ADDENDUM NO. 1
TO THE
DRAWINGS AND SPECIFICATIONS
FOR THE
17TH Street Reconstruction

Issued From: The City of Bloomington
Planning and Transportation Department
Post Office Box 100
401 North Morton Street, Suite #130
Bloomington, Indiana 47402

Issue Date: January 24th, 2019

SCALE	BRIDGE FILE
N.T.S.	N/A
	DESIGNATION
	N/A
SURVEY BOOK	SHEETS
N/A	52 of 100
CONTRACT	PROJECT
N/A	17TH STREET RECONSTRUCTION

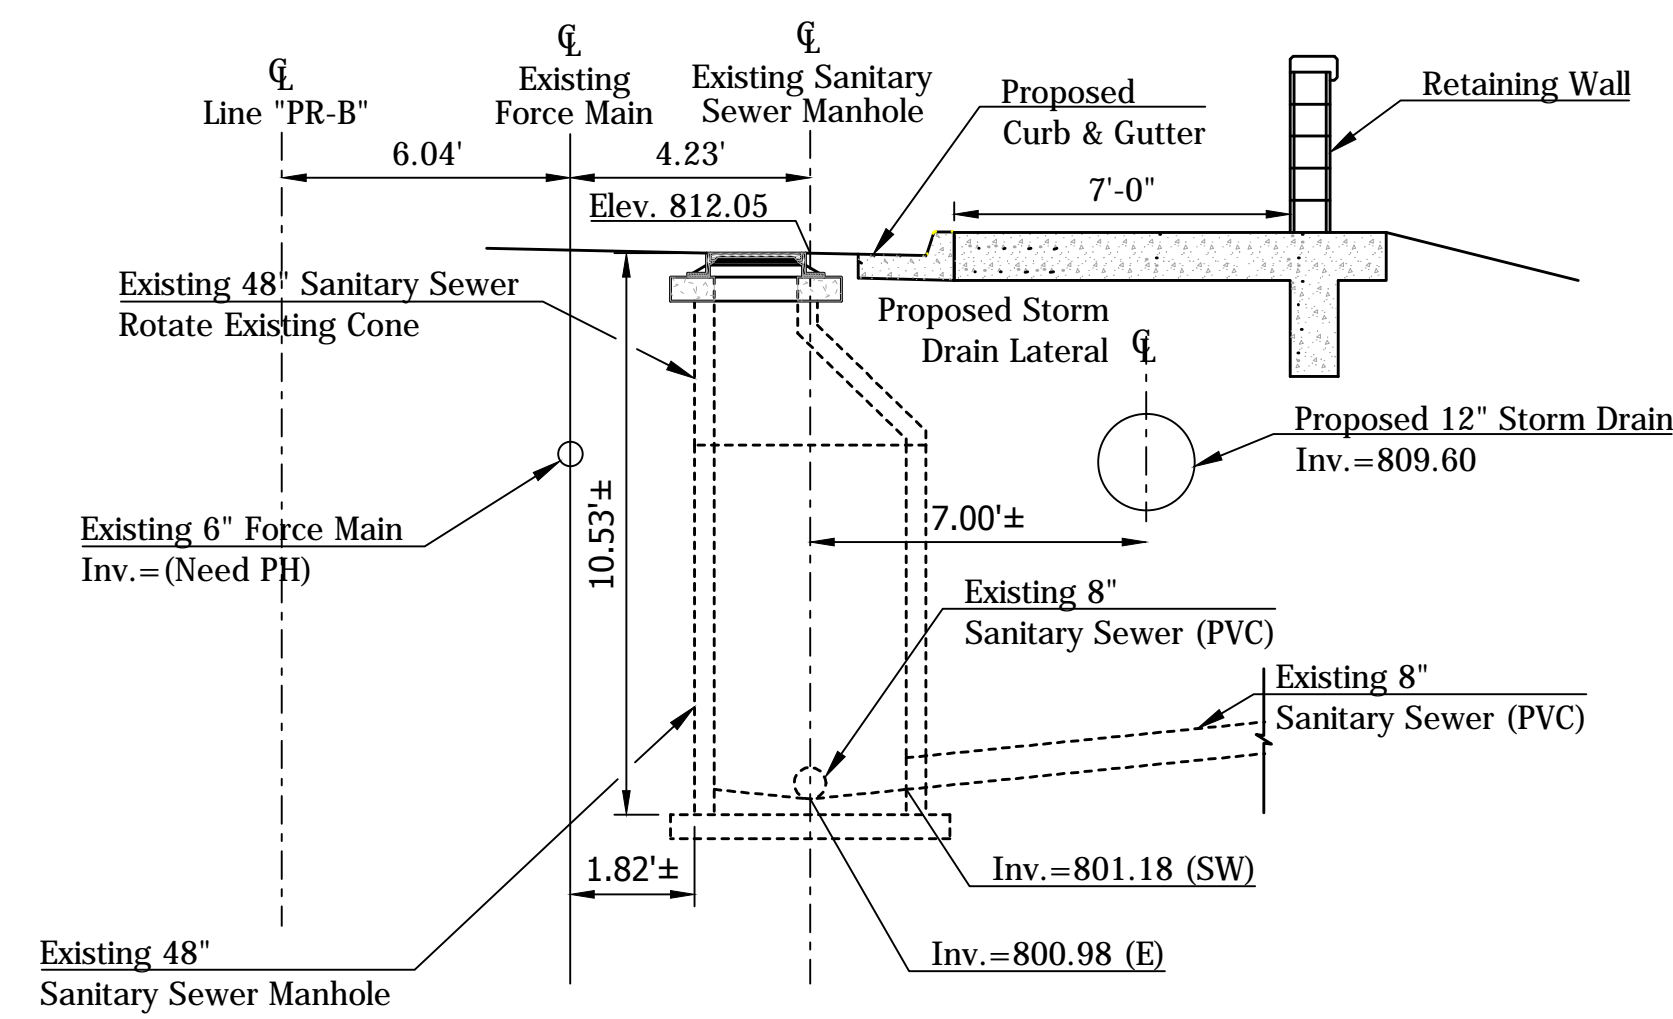
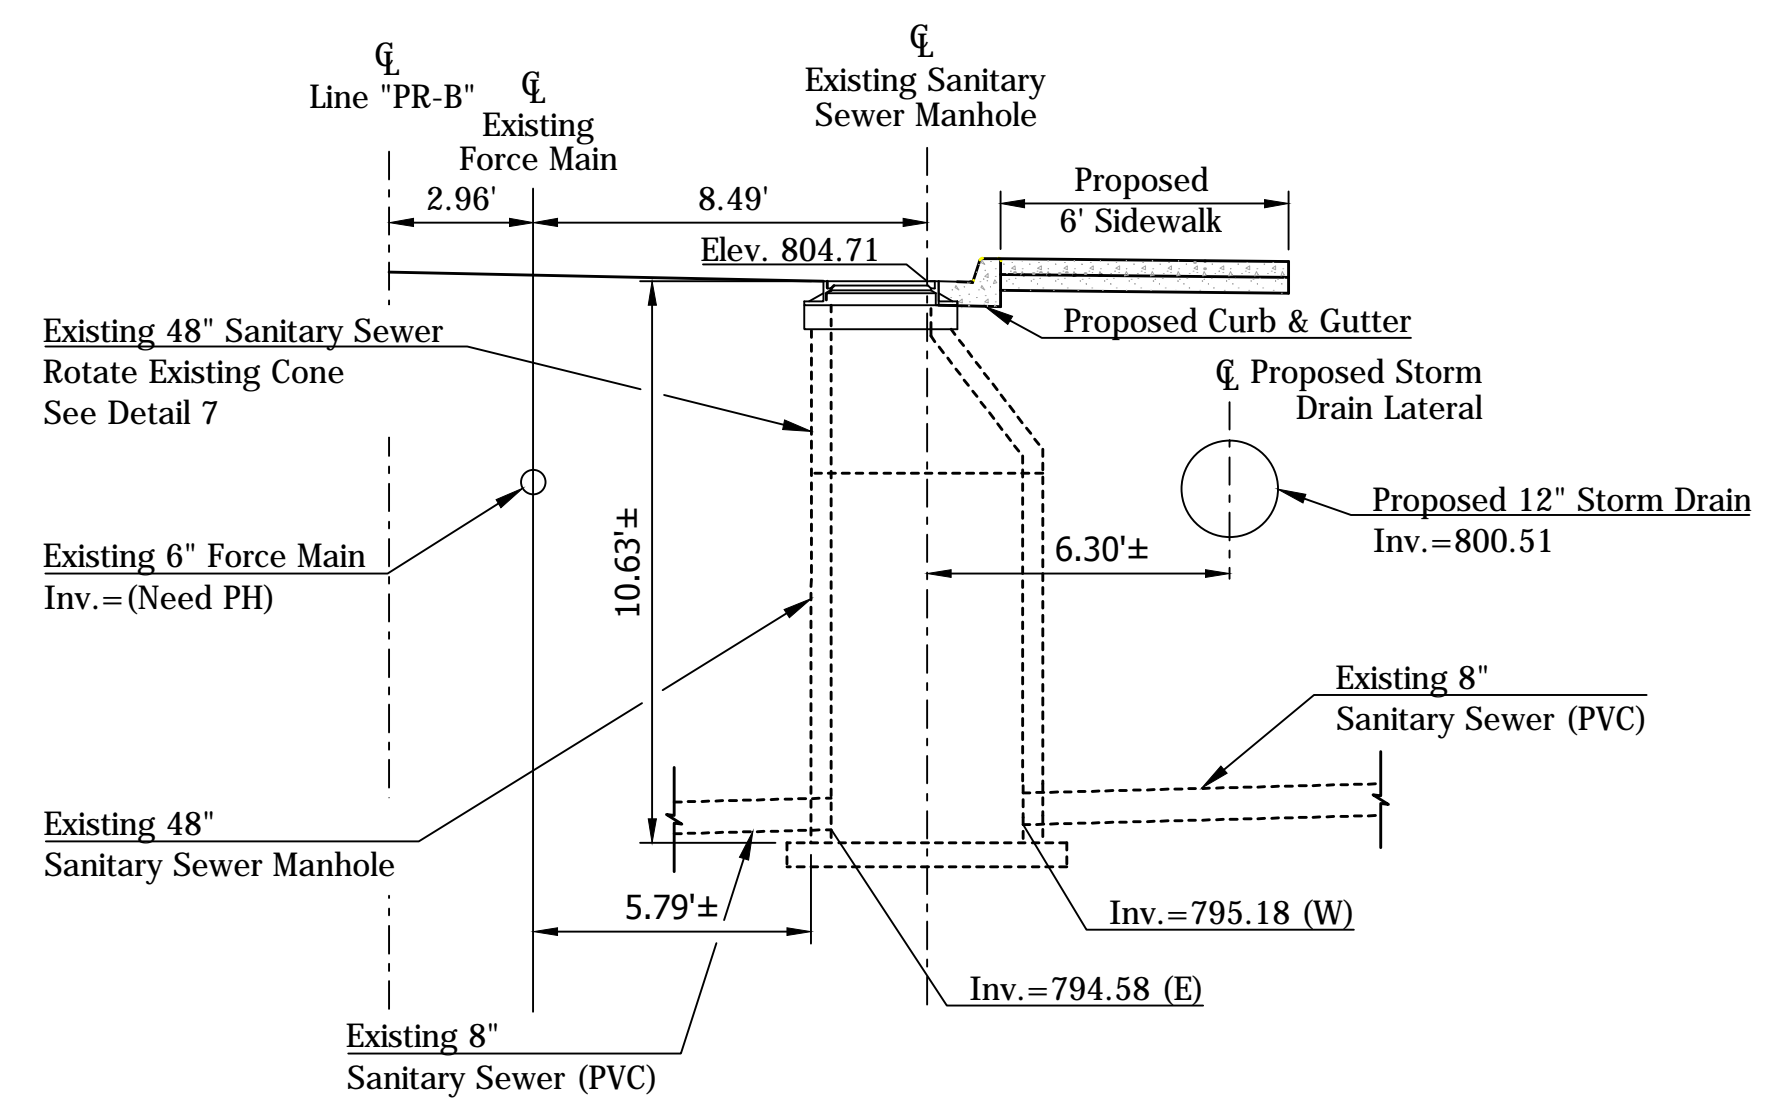
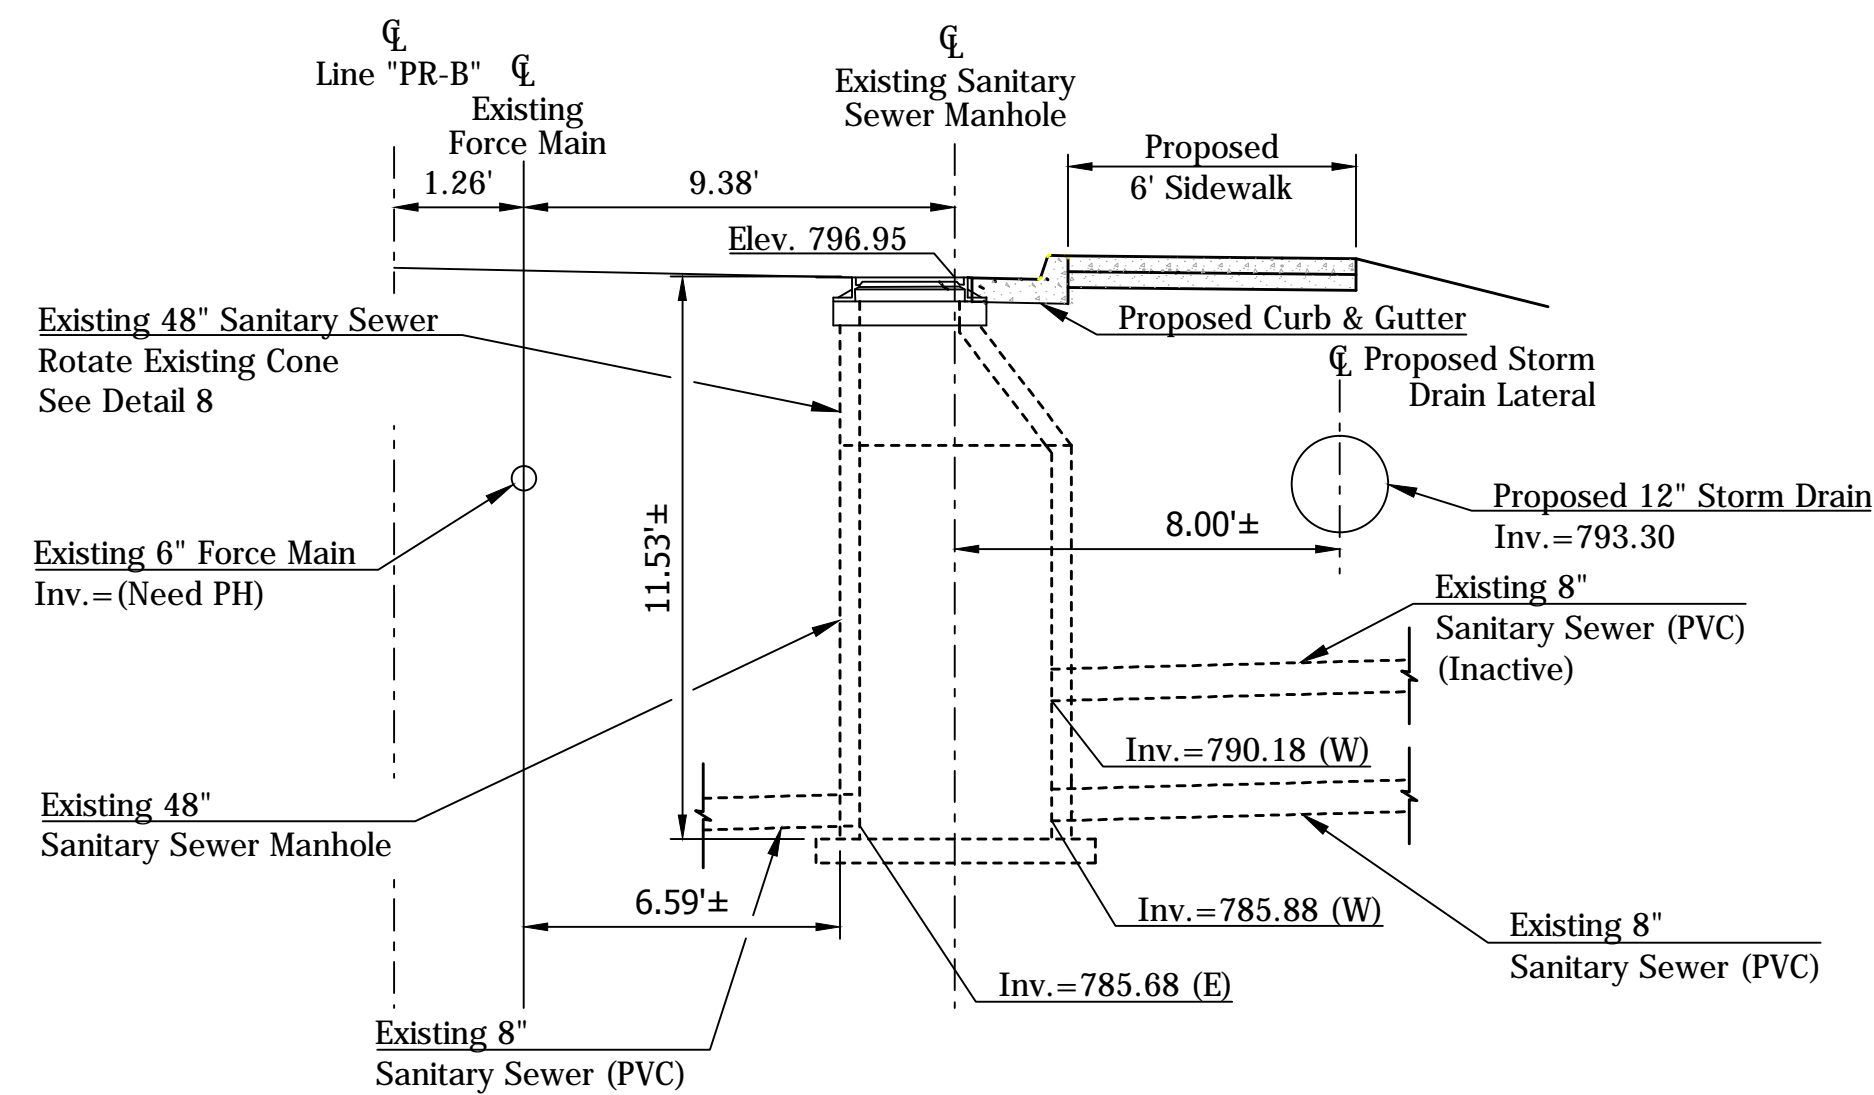
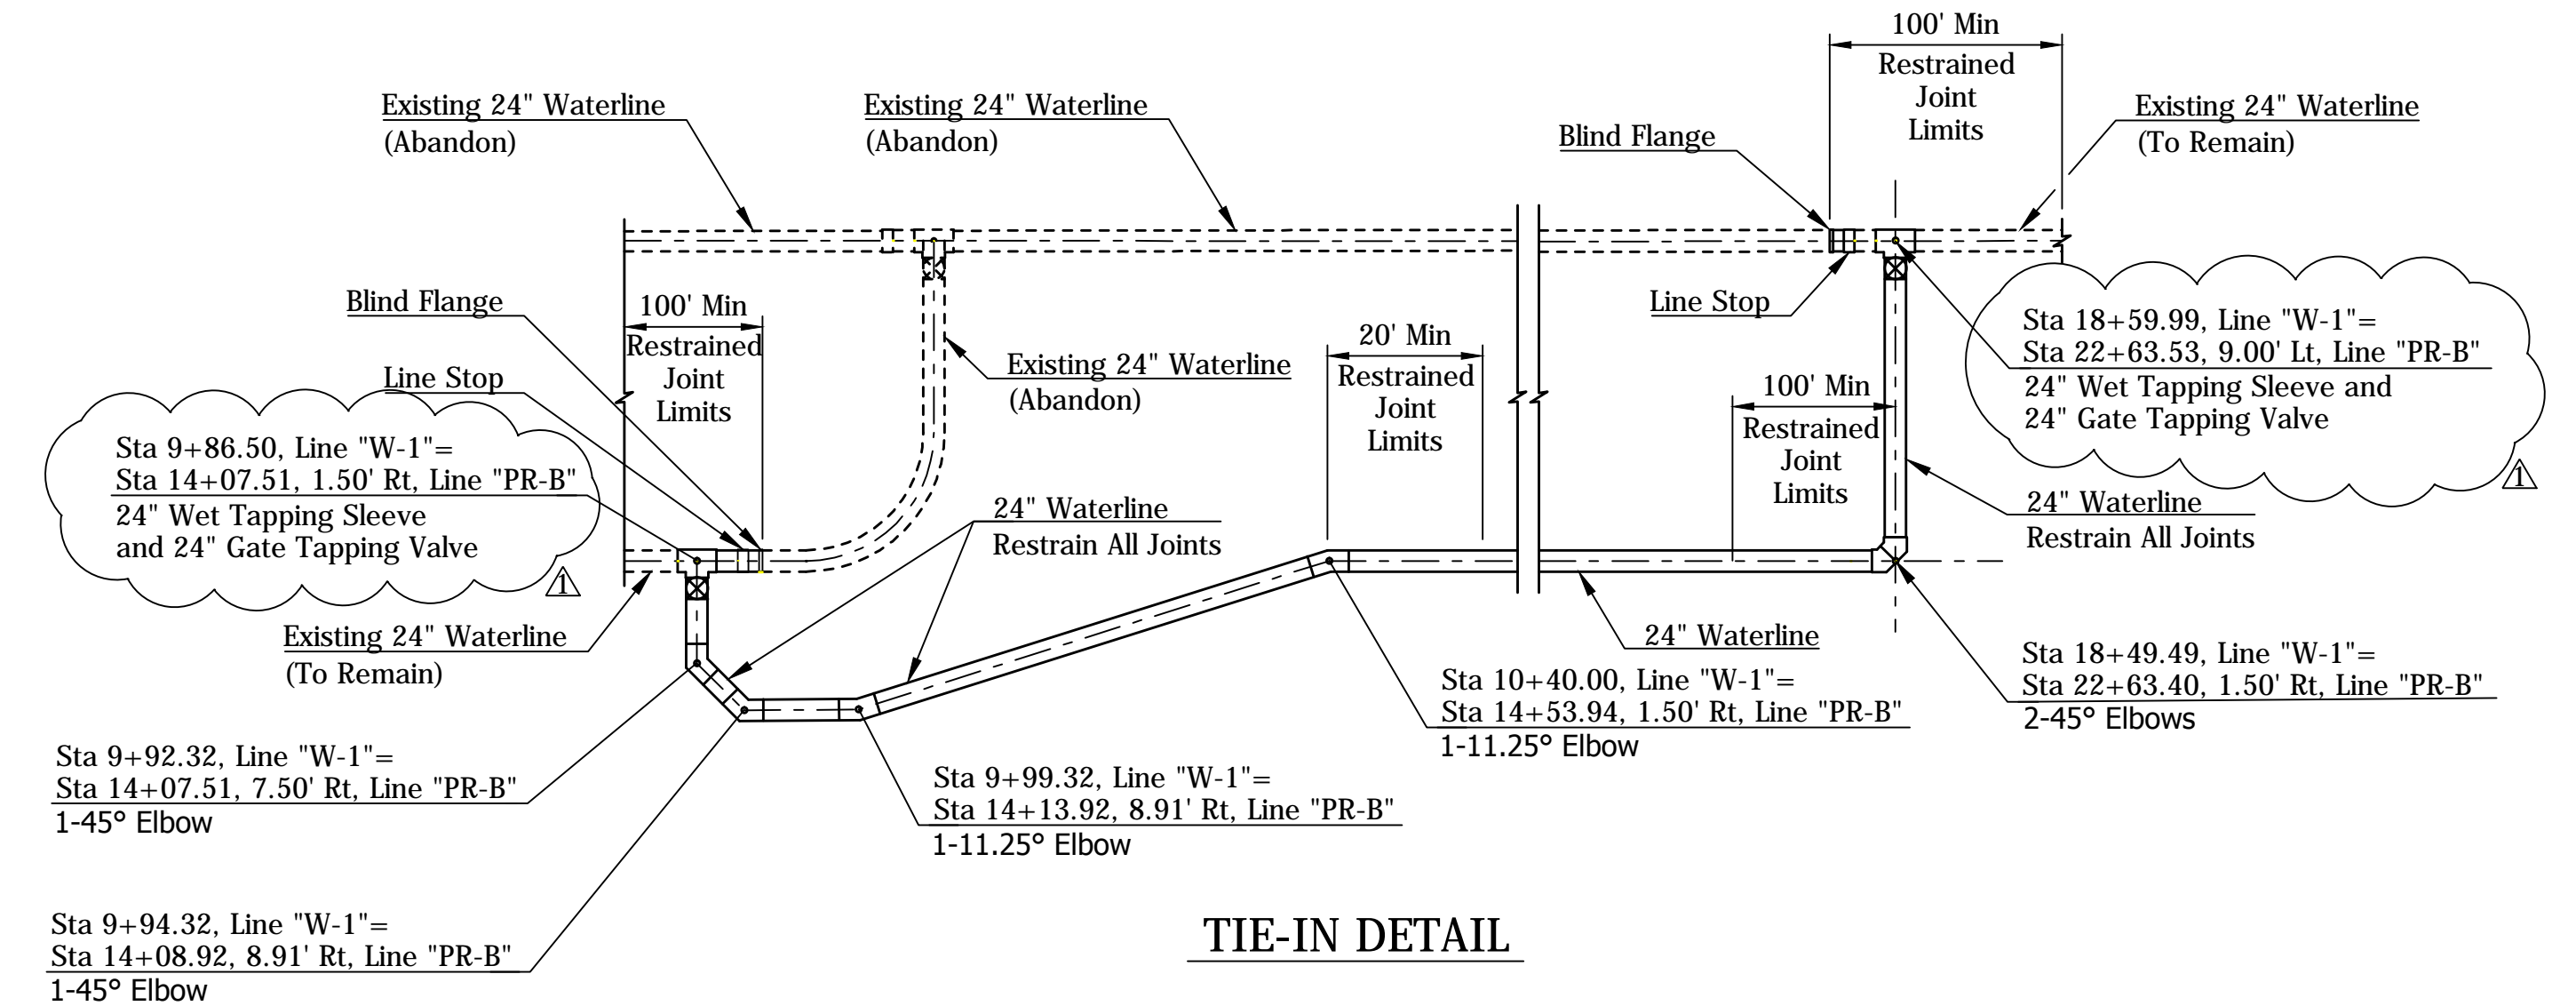
(Q) Are the gate valve items to pay for Valves as indicated, or Tapping Valves and Tap?

(Q) For the manhole modifications on plan sheet 52 will new steps need to be installed in the manholes?

(A) Gate tapping valves and tap. The Utility Details, sheets 52 & 53, have been revised to clarify the type of valves required. Revised plan sheets and a revised "Proposal Schedule of Items" have been added per this addendum.
